RA4M2 Group

Evaluation Kit for RA4M2 Microcontroller Group
EK-RA4M2 v1
Errata

Renesas RA Family
RA4 Series

Figure 1. USB FS Series Resistors R21, R22

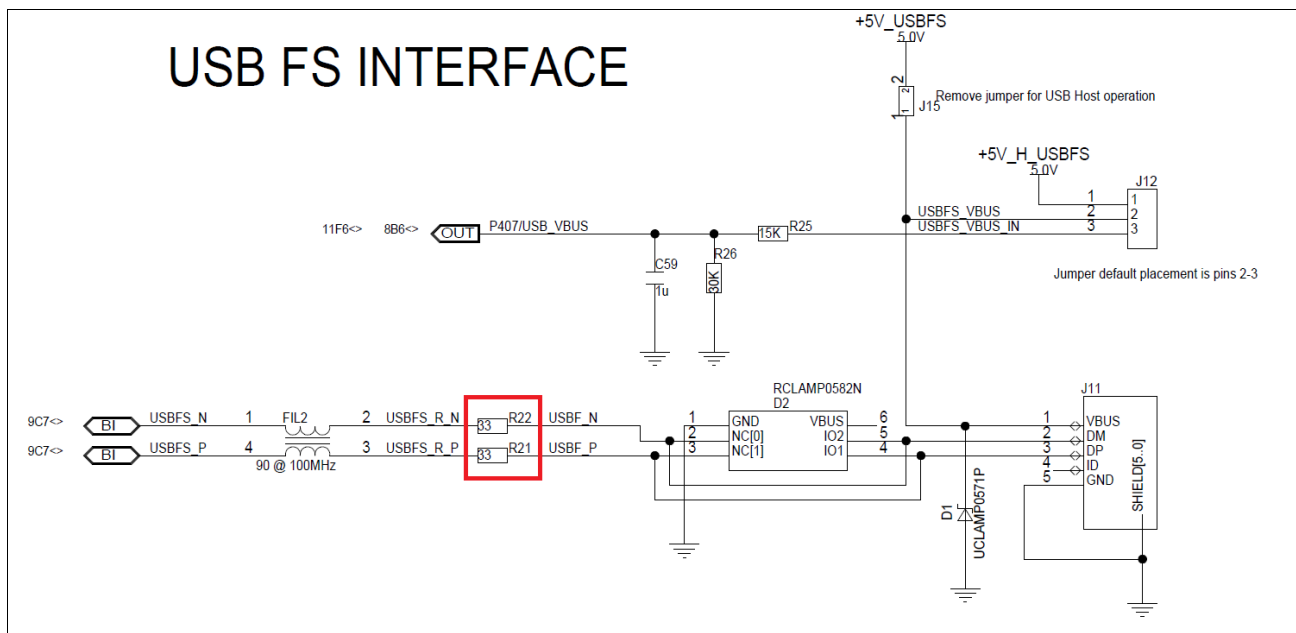
According to the following section in the *RA4M2 Hardware User’s Manual*, r01uh0892ej0101-ra4m2.pdf; **26.3.1.4 USB 2.0 Full-Speed Module (USBFS): Example external connection circuits**, the series resistors R21 and R22 in the USB FS interface should have a value of 27 Ω. On affected boards R21 and R22 are fitted with 33 Ω resistors. The EK-RA4M2 v1 schematic reflects these incorrect values as can be seen in Figure 1.

This kit has been confirmed to work with 33 Ω resistors so there is no need to replace them with 27 Ω resistors.

However, in your circuit design, be sure to insert a 27 Ω resistor into the USB differential line to satisfy the characteristics of the USB module.

None. The resistors R21 and R22 have the correct value of 27 Ω on later builds of the board. The schematic has been updated to show the corrected values.

Figure 3. Silkscreen Error for MCU SRAM

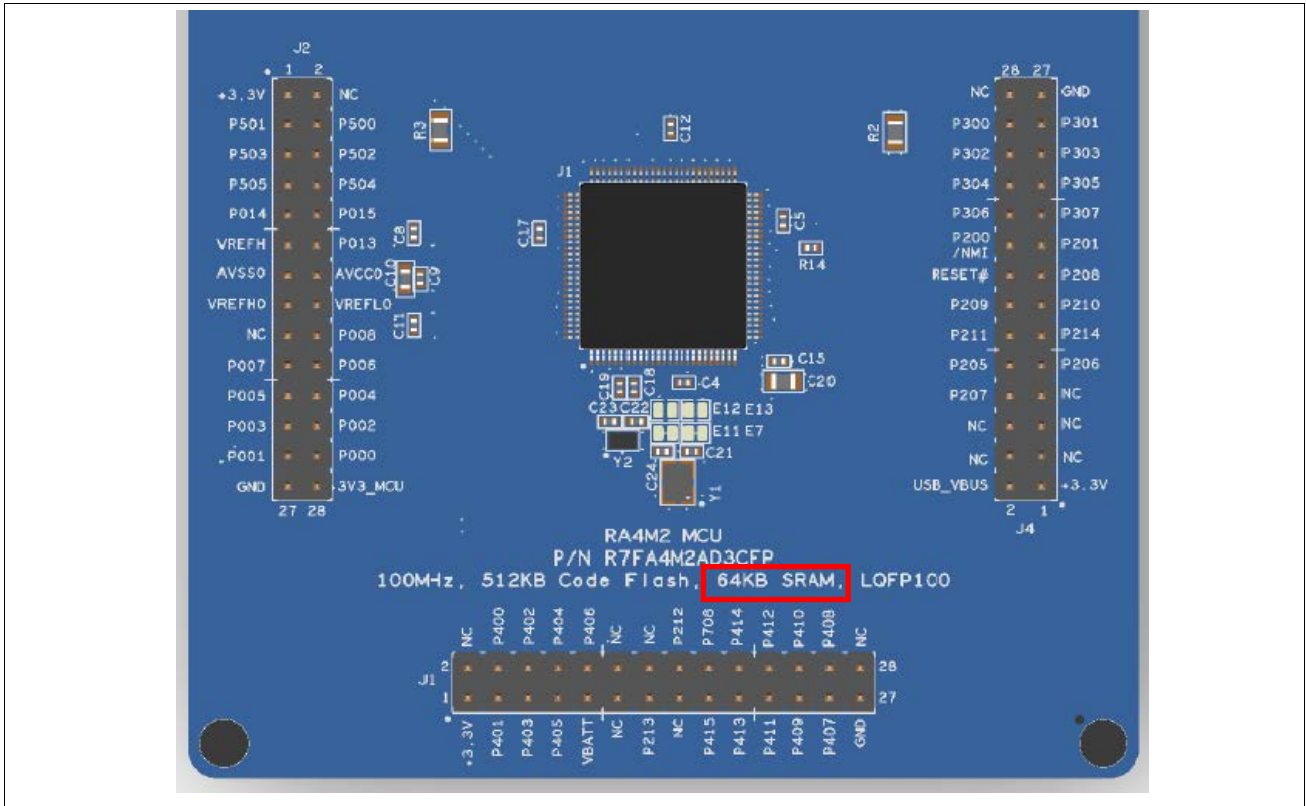
The board silkscreen provides details of the MCU SRAM size. This is identified as 64KB SRAM when it should be 128KB.

None. The silkscreen has been corrected to show the correct pin identification on later builds of the board.
